Application No. K 49265

Permit No. R 6159

Proof of Appropriation of Water

Application for a Permit to Construct a Reservoir and to
Store for Beneficial Use the Unappropriated
Waters of the State of Oregon

FINAL PROOF SURVEY UNDER

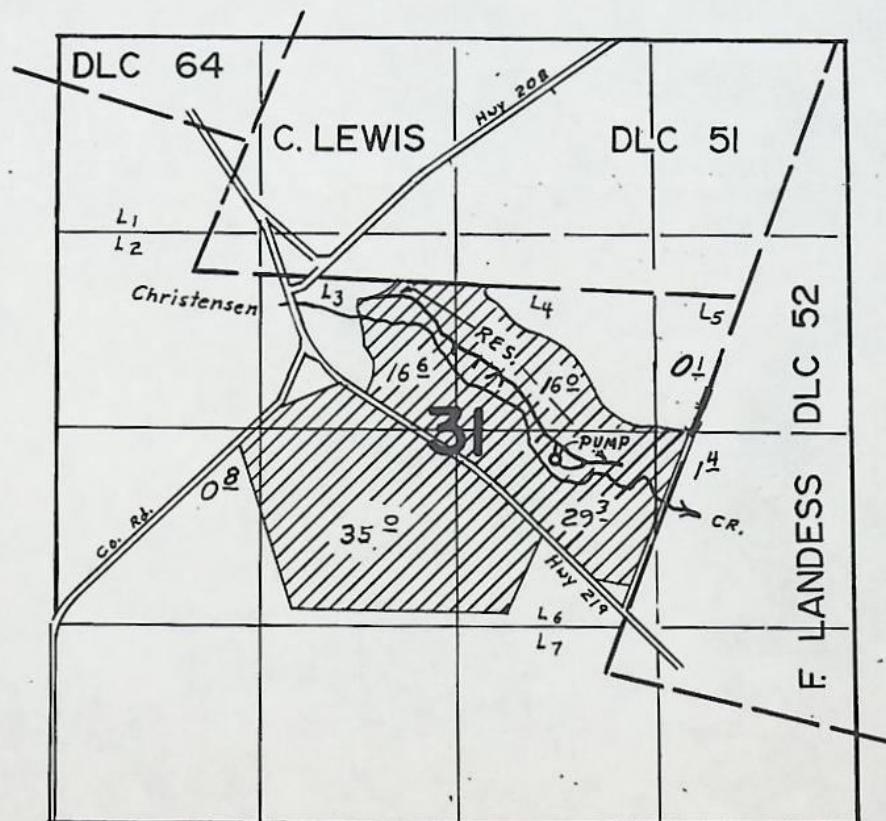
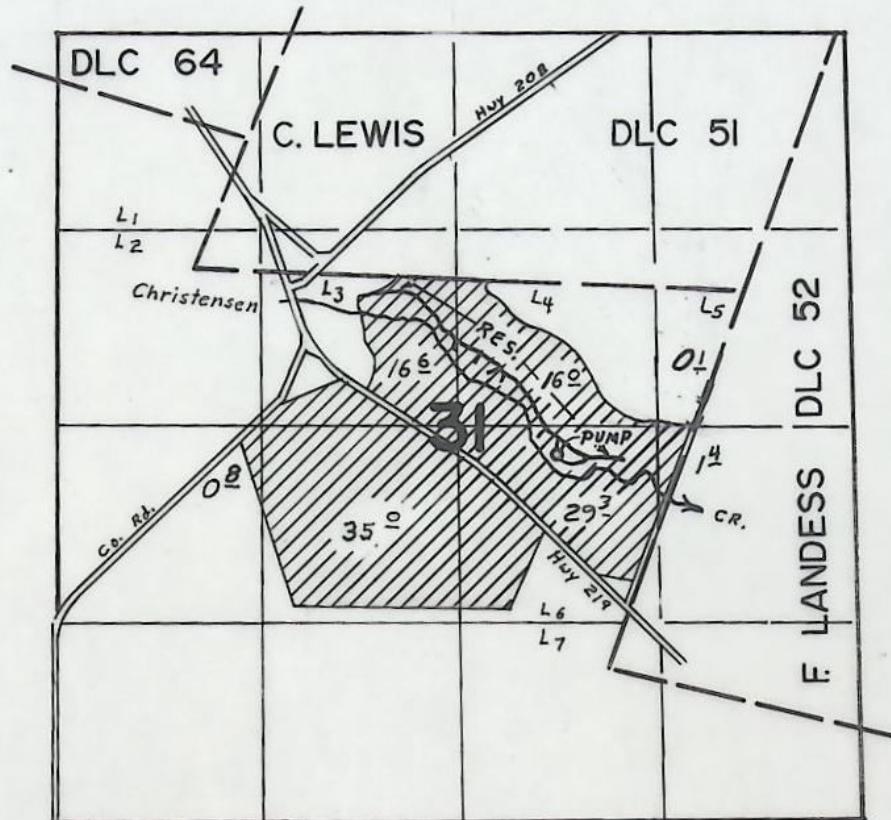
It was okayed by T.S. to add the 10^2 ac. supp'ls.
on the North end ~~to compensate~~^{AS} since it is
irrigated and since they were 10^3 Acres short
on primary & supp'ls. ~~or~~ below the 40 line.

TIE: Photo DBS- 466-26

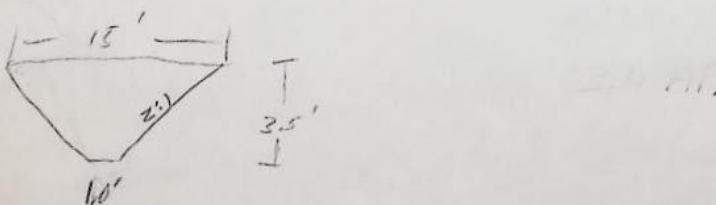
INFO: Louis Malenky, Jr.: There is no use from Campbell Cr (AKA Christianson Cr.). Malenky says there is a connection w/ creek to Res. #1 @ E. end but water would flow back into creek instead if opened. Res. is unn. ditch & portions of old Campbell Cr. channel. They straightened out the creek channel.

Res. #1 SURVEYED ON PHOTO AS LINE ON NO. SIDE OF CREEK.
Depth is 5' deep at E. end & tapers to about 2' deep @ upper end. Width varies from approx 5' to 20' wide.
Avg. width approx 15'. Inside slopes are 2:1, dug w/ backhoe.

$$\text{VOLUME} = \frac{(2650)(15+1)}{2} \times 3.5 \div 43560 = 1.7 \text{ A.F.}$$

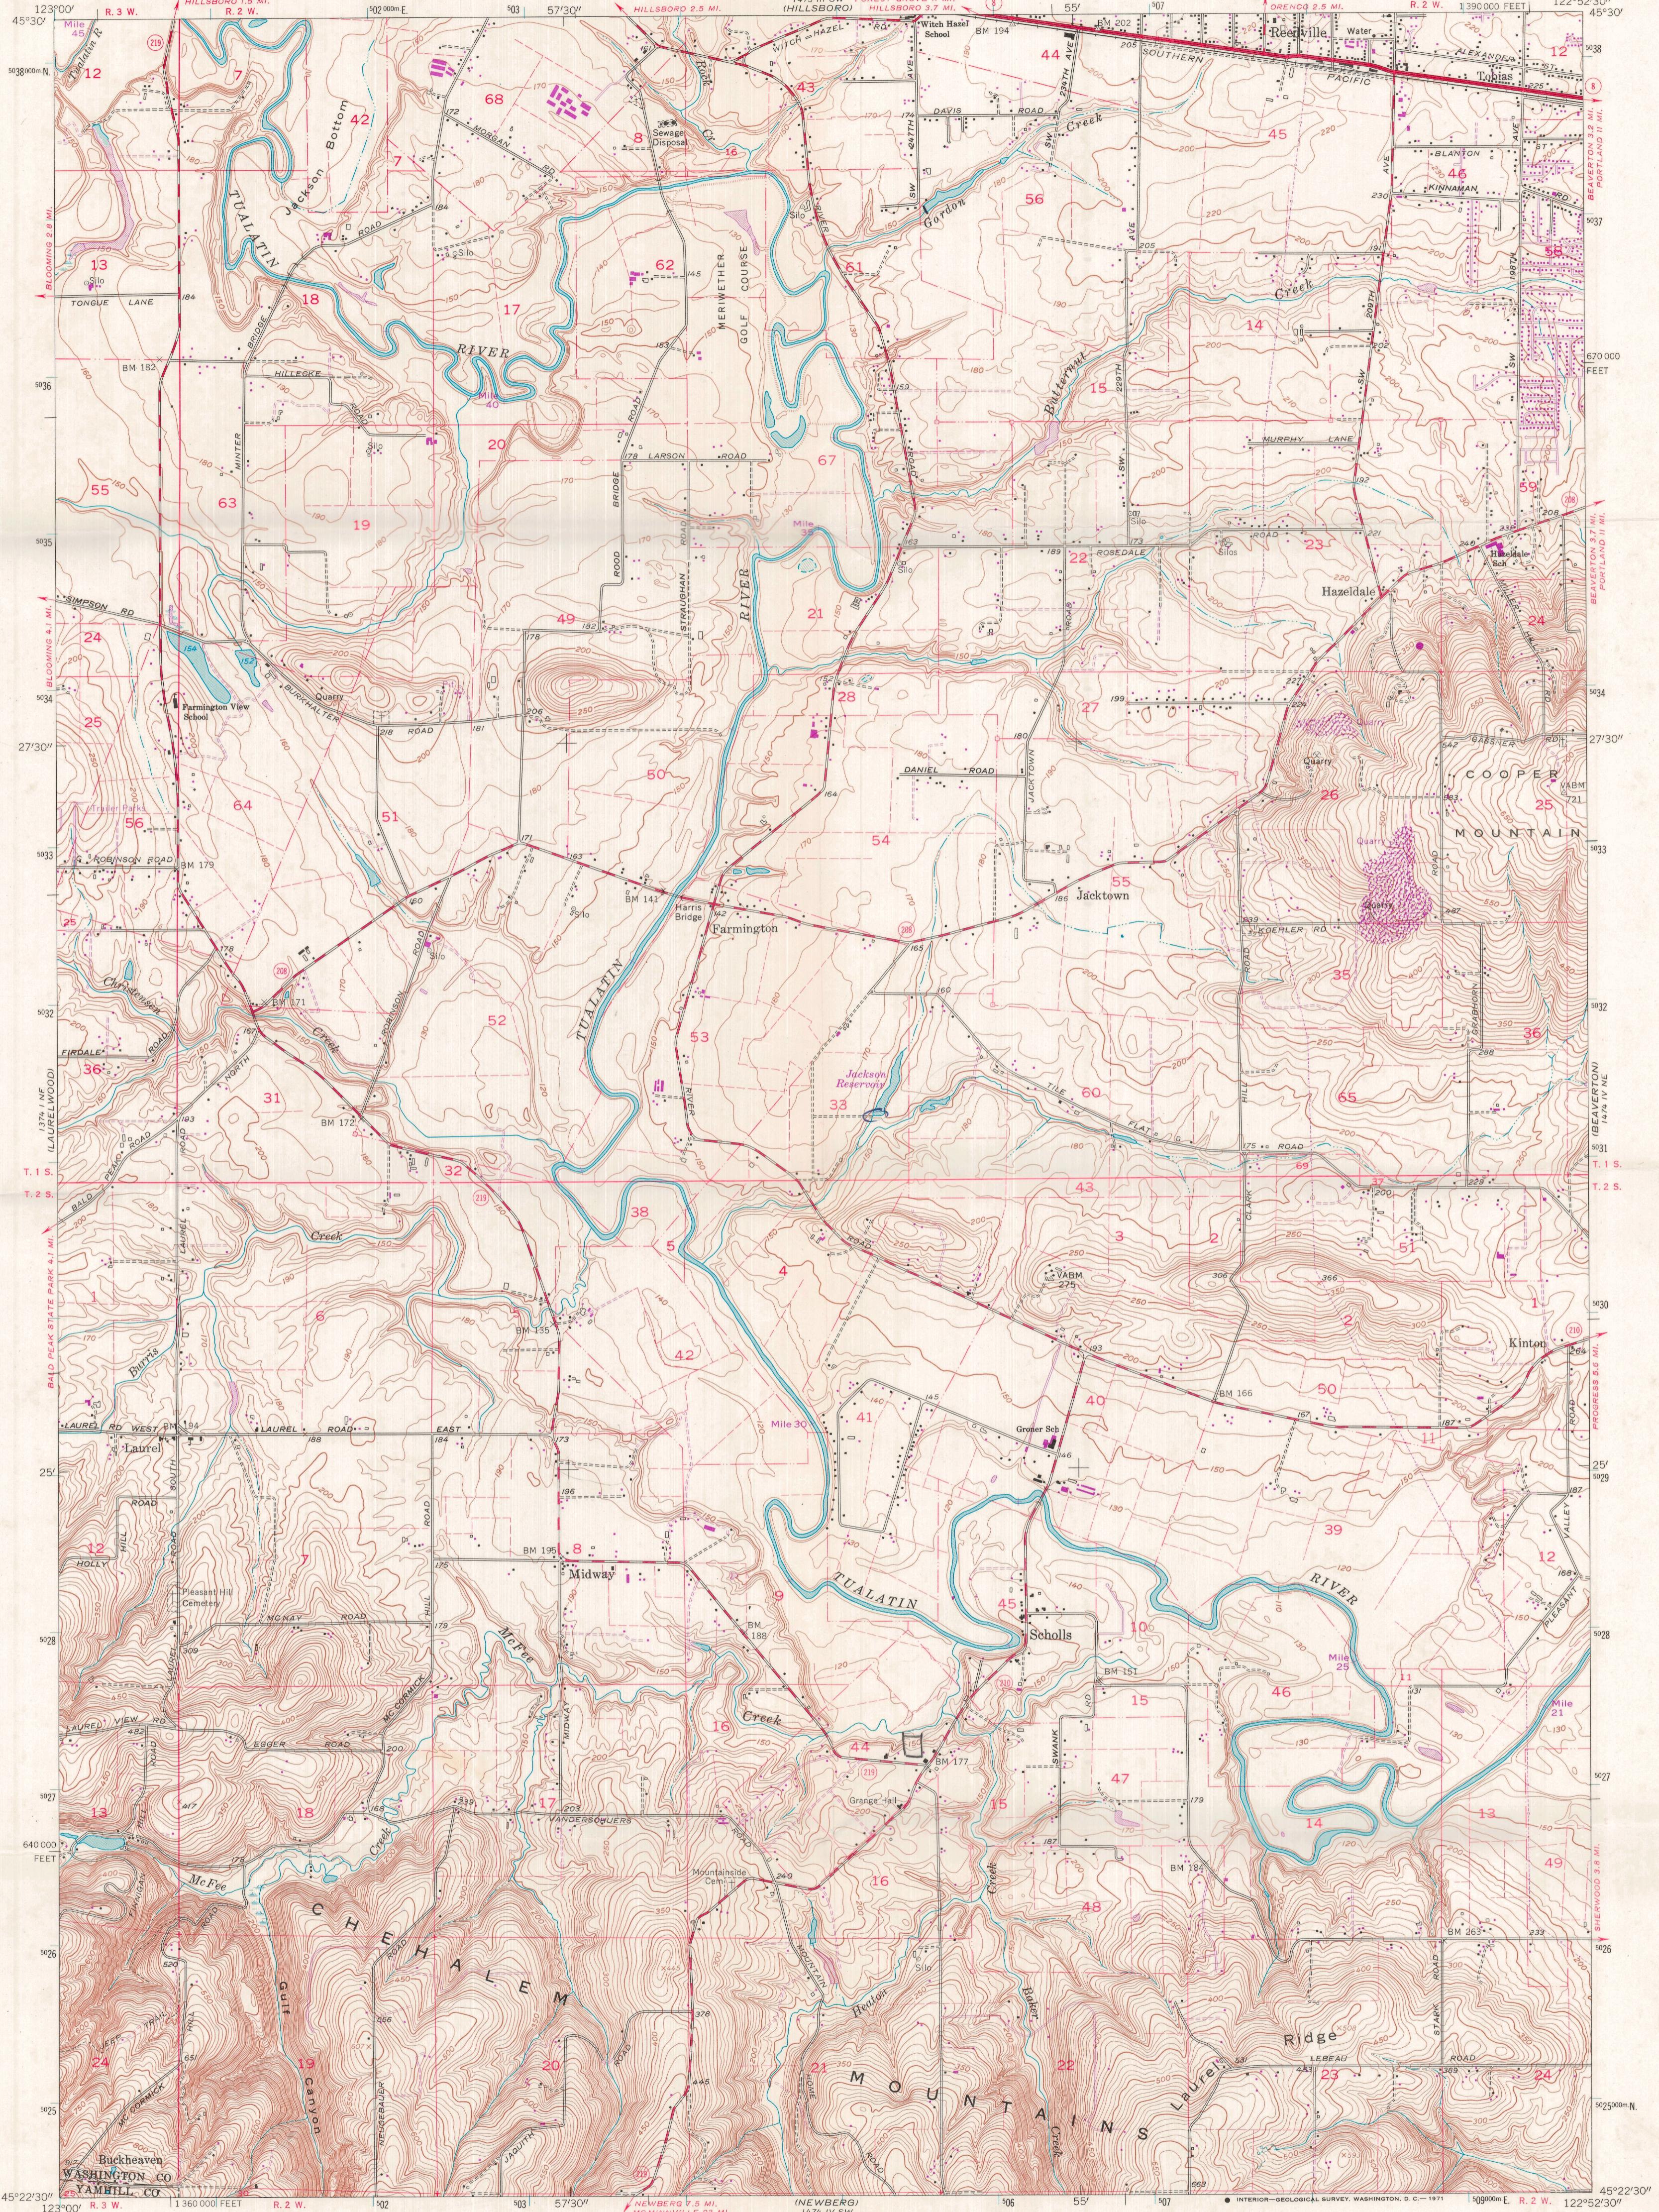
Maybe this is a good example of why the lands to be irrigated from each source should be shown.

Makensky planned to use Campbell Cr & 2 reservoirs along with a drainage ditch & 3rd reservoir for irrigation & supplemental irrigation purposes. He only requested 0.02 cfs from the ditch.

Our survey shows he did not make proof for Campbell Cr & Res. so, he has 0.02 cfs to irrigate 143.1 acres & 38.1 acres supplemental. He should like for more water, but how many acres do we allow on permit ^{all primary} 38077? I would like to at least delete supplemental bounts. Yes

Need info from hydrogeologist whether ^{diversion} hydrologically connected to creek.

We'll issue cert for .02 cfs from ditch, and storage for primary on 38077 and inform him that ground water being used by this system from "res" should be filed on as ^{as sum} ~~as sum~~. He may be supplying all add'l water from well under 6-5692. He did not build 2 flash board dams intended on cr to divert creek water into Res.
